MEMORANDUM

From:	Louise Aparo Ecology Officer		
Service	WBC Ecology	App No:	252494
Address:	Whitehouse Farm, Beech Hill Road, Spencers Wood, Wokingham, RG7 1HR.		
Proposal:	Application for submission of details to comply with the following condition of planning consent 232560 dated 14.03.2024. Condition 22 relates to external lighting.		
Type of Development:			
Site Visit Made:	Yes/No

Image 1: Orange dot indicates the appropriate bat box location based on lux levels.

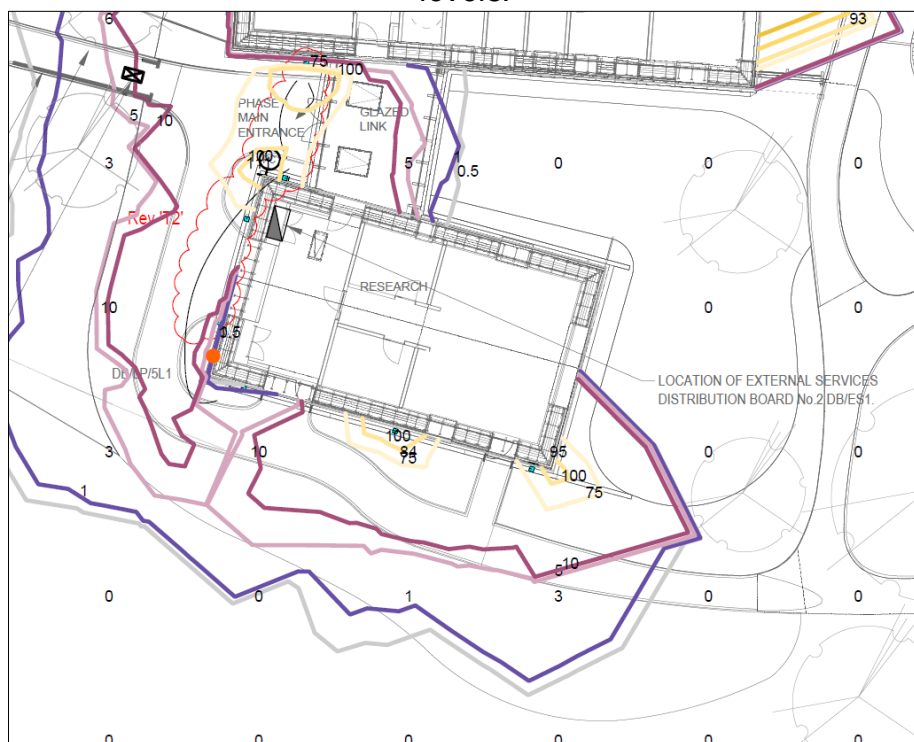
Regarding bat boxes proposed on the western gable, the plan shows higher lux levels in proximity to emergency lighting. It is understood that these levels represent emergency lighting required for building control compliance and that lights will

remain off unless triggered. To minimise potential interference, it is advised that the bat box be positioned on the southern side of the western gable, as indicated below.
